## *City of Jeffersonville's Responses to the List of Technical Questions Regarding Jeffersonville LTCP Amendment Proposal.*

The following list of questions is being submitted to Jeffersonville by U.S. EPA and IDEM regarding the proposal outlined in Jeffersonville's October 20, 2017 letter and October 24, 2017 supplement. These questions relate solely to the technical/engineering aspects of Jeffersonville's outlined LTCP amendment proposal. These questions are meant to continue the information exchange but are not intended to constitute an exhaustive list of questions or concerns that U.S. EPA and IDEM may have regarding Jeffersonville's submittals to date. These questions do not reflect U.S. EPA's and IDEM's concerns regarding Jeffersonville's financial justification for an LTCP modification; nor do these questions presuppose that a financial case for LTCP modification has been adequately demonstrated.

**Downtown WWTP – Proposed Situation – Between 25.0 and 50.0 MGD Flow**

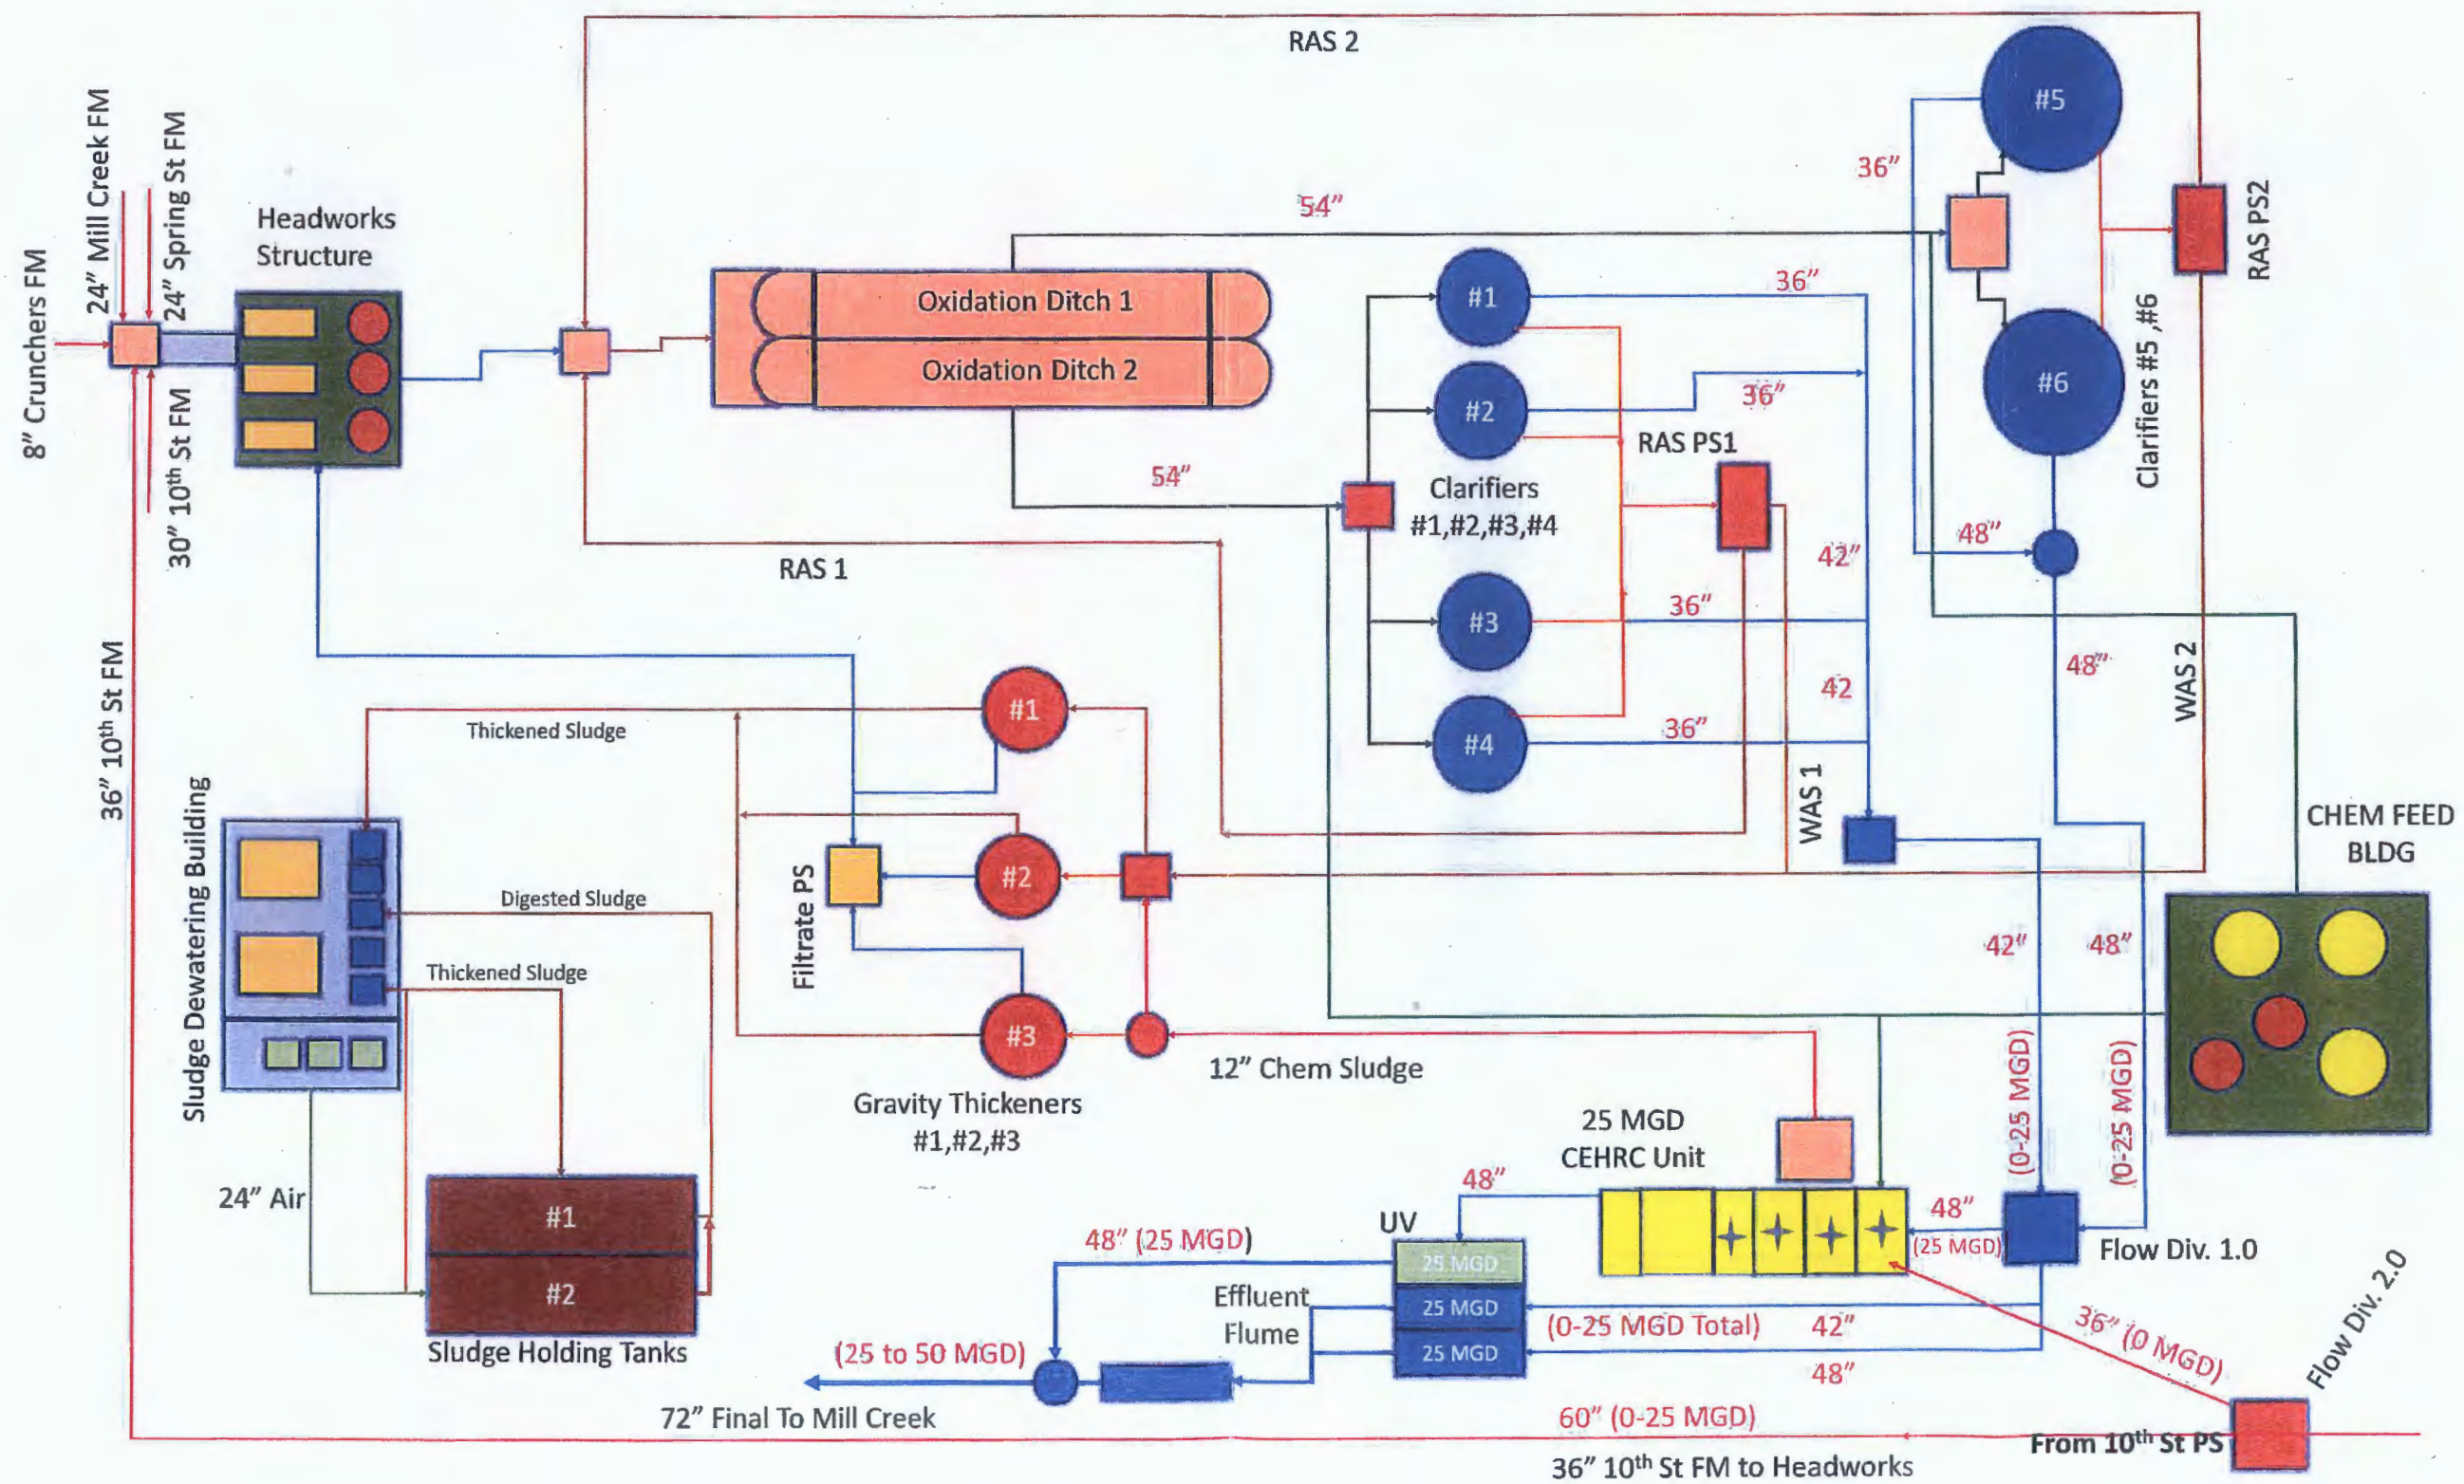
2. Please provide a current flow diagram of the downtown WWTP (including the headworks), and please provide a flow diagram showing the proposed sewer layouts for the 10<sup>th</sup> Street PS and downtown WWTP (including the CEHRT), including the proposed point of sampling for the recombined effluent.

*Process Schematic showing the DWWTP with influent flow between 25.0 and 50.0 MGD; and*
